Access Compliance Report

Public Rights-of-Way

(Pedestrian Signals)

Intersection ID: N/A	Main Street:	Cross Street: N/A	Location: N/A
ADA ID: C8C4E3F5E7F7	Signal Type: Two Push Buttons-APS	Overall Compliance: No	Severity Score: BTN 1:N/A BTN 2: N/A No BTN: N/A
Codes/Mitigation Info/Possible Solution		Field Measurements/Component Compliance

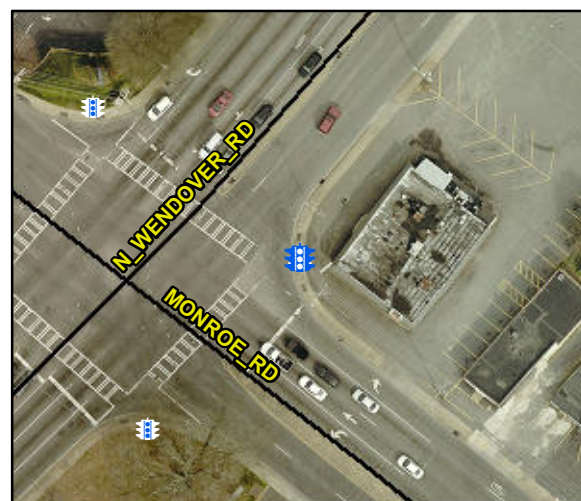
PROW/ADA: TMUTCD 4e.08, R404.2, R404.3, R406.2,

Compliance	Description	Data	Compliance	Description	Data
	Button Count	Button2	N/A	Distant to Additional Button (in)	N/A
	Additional Button Present?	No		Additional Button ID	N/A
N/A	Signal Buttons Required?	N/A	N/A	Additional Ped Posts Required	N/A
	How Many Ped Street Xings?	2		Located In An Island/Median?	No
N/A	B 1 Sign Present?	Yes	N/A	B 2 Sign Present?	Yes
Yes	B 1 Sign Purpose?	Yes	Yes	B 2 Sign Purpose?	Yes
Yes	B 1 Sign Lettering & Contrast?	Yes	Yes	B 2 Sign Lettering & Contrast?	Yes
Yes	B 1 Parallel To XWalk?	Yes	Yes	B 2 Parallel To XWalk?	Yes
Yes	B 1 PAR to Button?	Yes	Yes	B 2 PAR to Button?	Yes
Yes	B 1 PAR to XWalk?	Yes	Yes	B 2 PAR to XWalk?	Yes
Yes	B 1 Clear Floor Space?	Yes	Yes	B 2 Clear Floor Space?	Yes
N/A	B 1 FWD Approach?	Yes	N/A	B 2 FWD Approach?	Yes
N/A	B 1 FWD Approach Constrained?	No	N/A	B 2 FWD Approach Constrained?	No
No	B 1 FWD Approach Reach (in)	8.0	No	B 2 FWD Approach Reach (in)	8.0

N/A	B 1 FWD Approach Width (in)	N/A	N/A	B 2 FWD Approach Width (in)	N/A
N/A	B 1 FWD Approach Obstruction?	Yes	N/A	B 2 FWD Approach Obstruction?	Yes
N/A	B 1 FWD Approach Obstruction Dist (in)	6.0	N/A	B 2 FWD Approach ObstructionDist (in)	6.0
N/A	B 1 PARA Approach?	Yes	N/A	B 2 PARA Approach?	Yes
N/A	B 1 PARA Approach Constrained?	No	N/A	B 2 PARA Approach Constrained?	No
Yes	B 1 PARA Approach Reach (in)	8.0	Yes	B 2 PARA Approach Reach (in)	8.0
N/A	B 1 PARA Approach Width (in)	N/A	N/A	B 2 PARA Approach Width (in)	N/A
N/A	B 1 PARA Approach Obstruction?	Yes	N/A	B 2 PARA Approach Obstruction?	Yes
N/A	B 1 PARA Approach Obstruction Dist (in)	6.0	N/A	B 2 PARA Approach ObstructionDist (in)	6.0
No	B 1 Clear Floor Space Slope (%)	3.0	No	B 2 Clear Floor Space Slope (%)	3.1
No	B 1 Clear Floor Space XSlope (%)	4.3	No	B 2 Clear Floor Space XSlope (%)	4.5
N/A	B 1 PAR Slope (%)	2.4	N/A	B 2 PAR Slope (%)	1.9
Yes	B 1 Height (in)	37.0	Yes	B 2 Height (in)	37.0

Yes	B 1 Clear Xing Direction?	ClearlyMarked	Yes	B 2 Clear Xing Direction?	ClearlyMarked
	B 1 Crossing Direction	To NW		B 2 Crossing Direction	To SW
No	B 1 DistanceTo XWalk (in)	112.0	No	B 2 DistanceTo XWalk (in)	119.0
Yes	B 1 DistanceTo Curb (in)	66.0	No	B 2 DistanceTo Curb (in)	74.0
Yes	B 1 Diameter (in)	2.0	Yes	B 2 Diameter (in)	2.0

Possible Solutions: Replace Signal Push Button With APS Button on New Post. Remove & Relocate Sign.
